CUMBERLAND
CITY COUNCIL

Ref: OA2020/0013

Subject: Request for comments-State Significant Development (SSD)
Application No: SSD-10407
Property: 14 & 16 Kiara Crescent YENNORA NSW 2161
Proposal: Ministerial Consent - Expansion of existing liquid waste treatment facility for increasing processing and storage quantities and hours of operations to 24/7

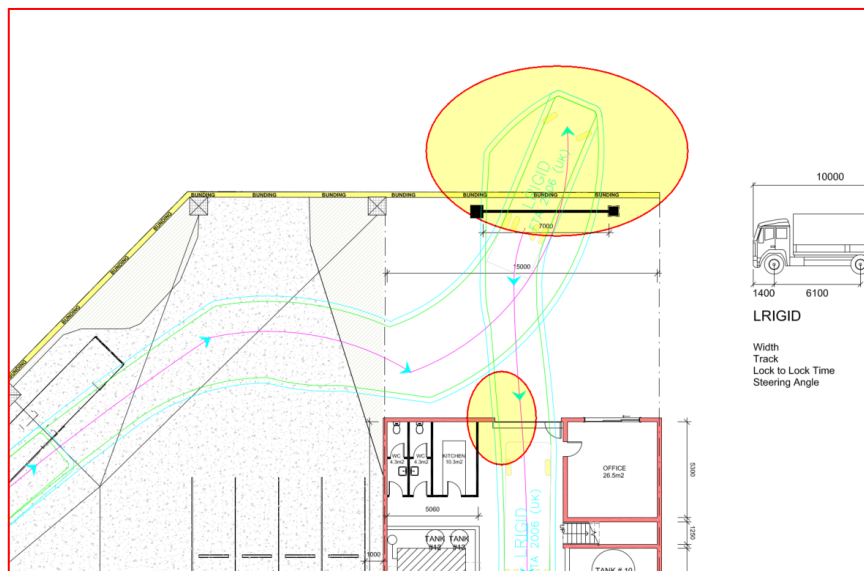
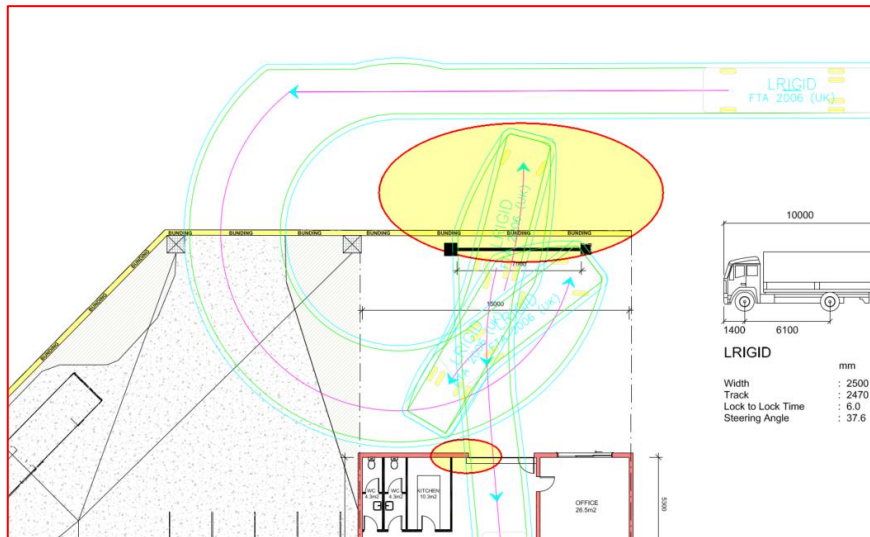
- a) The 10.0m truck used in the swept path analysis is not a standard truck that is defined in Australian standard AS2890.1. Further, the swept path clearance turning with 12,5 standard turning circle must be used.

- b) The manoeuvring and turning of the vehicle must be completed within the site and must not cause encroachment into nature strip or the footpath. The swept path diagrams demonstrate otherwise with the encroachment into nature strip.

- c) Sufficient swept path diagrams must be provided to demonstrate that the turning and manoeuvring of the truck is possible for all, entry and exit for both processing plant. The swept path must demonstrate with a truck in the waiting/stand-by bay.

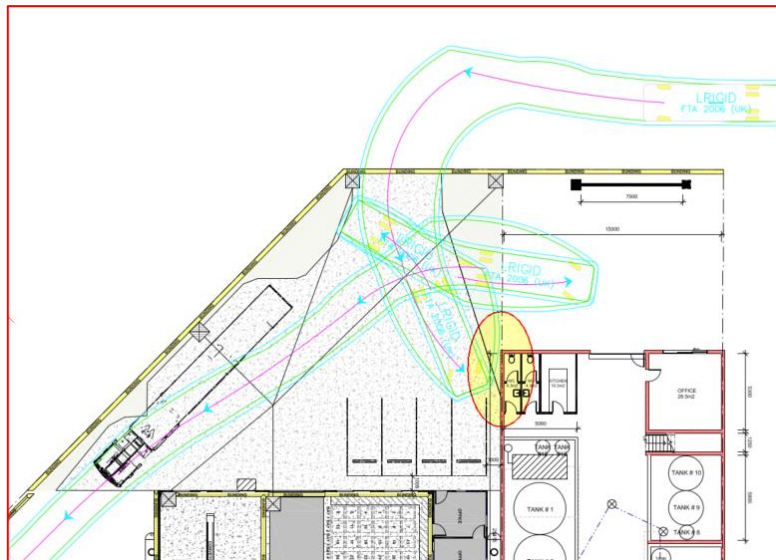
- d) Further, the Truck swept path diagram also indicates the runover into the structure (entrance door jamb) and the car space for 16 Kiora Place.
- e) Reverse manoeuvring in Council's land is not acceptable. It will compromise the safety. Vehicles should enter and leave the site in a forward direction.

- f) Multiple point turn (more than 3 points) will result in additional time for the turning and manoeuvring thus overlapping with the arrival of another vehicle (truck) and causing obstruction and delay. Enough space must be provided for manoeuvring and turning with the minimum delay. The proposed 4-point turn truck manoeuvring movement is not acceptable. Manoeuvring shall be limited to three-point turn.
